**WOKINGHAM
BOROUGH COUNCIL**

Outline Planning Approval Consultation

Application Number: 250517

MEMORANDUM

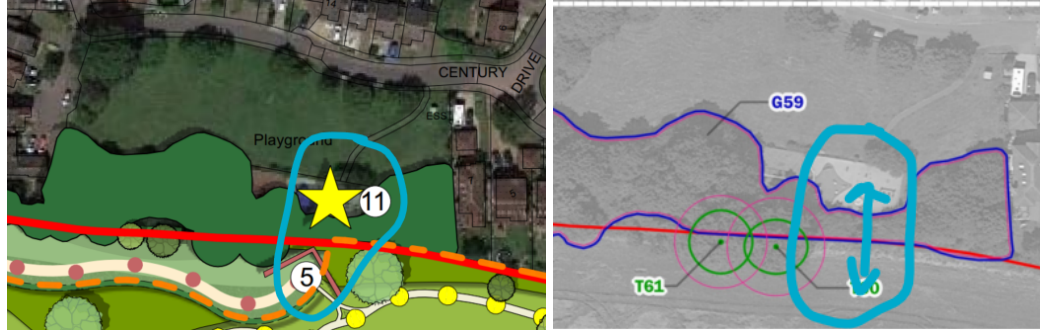
- e) With respect to connectivity and providing accessibility and links to external PRowWs and other footpaths, my comments below should be reviewed against those being made from Highways, Landscape, Ecology, and PRowW consultees.

Policy CC03 indicates that new developments should promote links and connections to PRowWs, footpaths, and bridleways external to the site. I appreciate that this scheme attempts to do so, however, more detail needs to be provided on how this will be accomplished safely and without impacts to existing trees and ecology.

- i) From a green infrastructure perspective, the connection to PRow Shin33 is a desirable link and should be pursued in line with Policy CC03. If this is an acceptable connection from a PRowW and Highways perspective, details of the connection will need to be provided.
- ii) I question the proposed pedestrian/ cycle connection to Barracks Lane shown at the northwest corner of the scheme. I appreciate the attempt to increase permeability and links to points outside of the development. I defer to Highways to comment if this can be accomplished safely considering Barracks Lane appears to be a very narrow lane that is fenced on the north side except where it connects to adjacent dwellings.

- iii) I again appreciate the attempt to increase links and permeability to points outside of the site. The proposed access point at the northeast edge of

the scheme is meant to provide connection to an off-site playground and Century Drive. Century Drive then provides further access to Hyde End Road. However, details of the access will need to be considered as there will likely be landscape and possibly ecology impacts with the removal of G59 vegetation to accommodate the footpath.

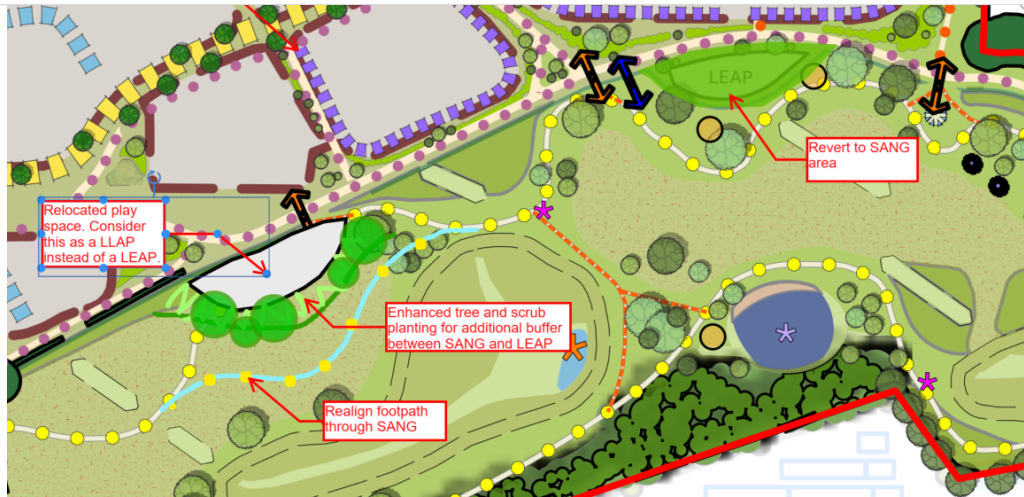
- a) In outline, I am satisfied that the development can meet policy requirements for CC03 and TB08 – the impacts of the development can be mitigated by the provision of the required quantum of play facilities for children and youth. The outline information that has been provided shows that the play facilities will be well connected to the entirety of the development, and, if designed appropriately, help establish a sense of place and well-being for the community while also providing access to high-quality recreation opportunities.

While in outline, the application has shown that CC03 and TB08 can be met, the application must further demonstrate compliance with the WBC Play Space Design Guide Technical Note.

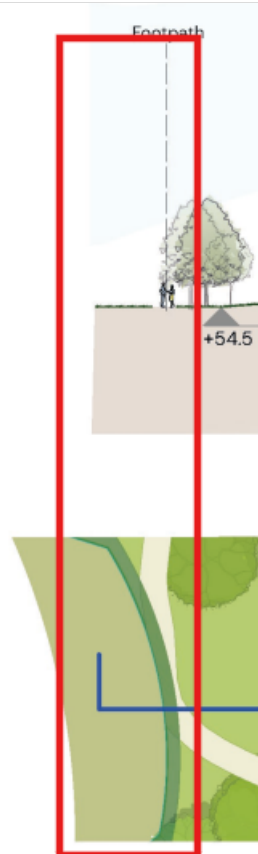
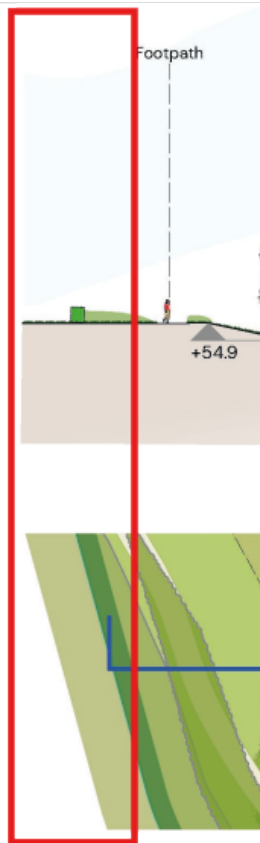
- 1) Based on the standard SANG provision rate of 8ha per 1,000 (2.4 residents per household) within 400m to 5km of the SPA, the proposed 420 dwelling unit development generates the need to 8.06ha of SANG. According to the EPR SANG Creation and Management Plan (3336-1E, dated 06 February 2026), the proposed development provides a total of 10.39ha of SANG. I have generally confirmed the 10.39ha area using in-house software. This is a welcomed increase as it appears that there will be wider accessibility to the SANG across the development.

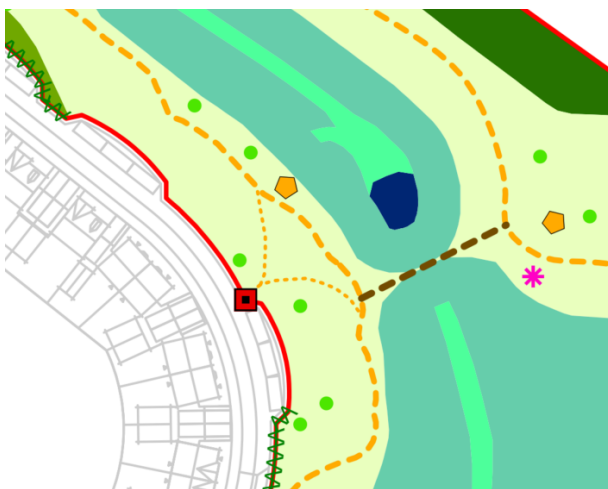
- ii) There are discrepancies between the SANG footpath alignment shown on the Illustrative Master Plan (P23-2449_EN_C_ILMP) and the SANG General Arrangement Plans in the EPR document. In the screen grab below from the GAs, the western footpath appears to be close to the attenuation pond whereas the alignment in the illustrative master plan shows the footpath closer to the western SANG boundary. This discrepancy is also shown in Section AA' of the sections that have been provided (P23-2449_EN_0014_0001).

I am interested to see where the footpath is located in this part of the SANG. A footpath location further to the east may lessen my concerns as it appears that this could allow for a footpath that is further from an urbanised edge, potentially down slope,

Please confirm the location of the footpath along the western boundary of the SANG. If the location of the footpath changes, please also confirm that length is still at least 2.3km.

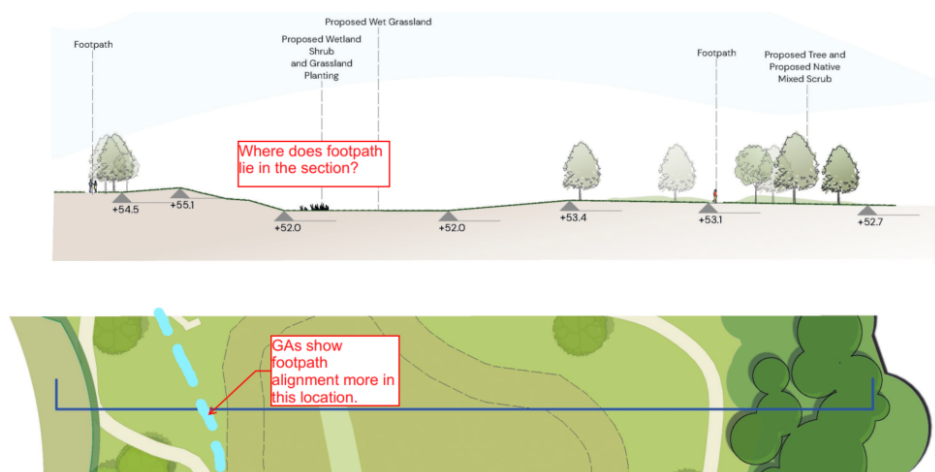
and with more options for a planting that could serve as a screen.

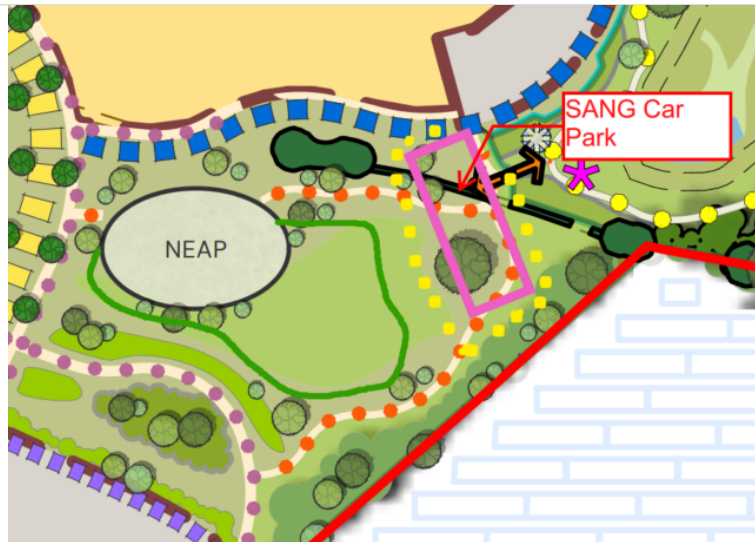
(7) A plan that addresses the delivery of the SANG car park must be provided. Without a delivery plan, it is difficult to know when the car park should be delivered. If areas of the development fall outside of the 400m distance, the car park should be delivered at the same time as the SANG, prior to first occupation.

However, if the entirety of the development falls within the 400m area and the SANG is accessible by footpath, it is possible that the car park could be delivered at a later point.
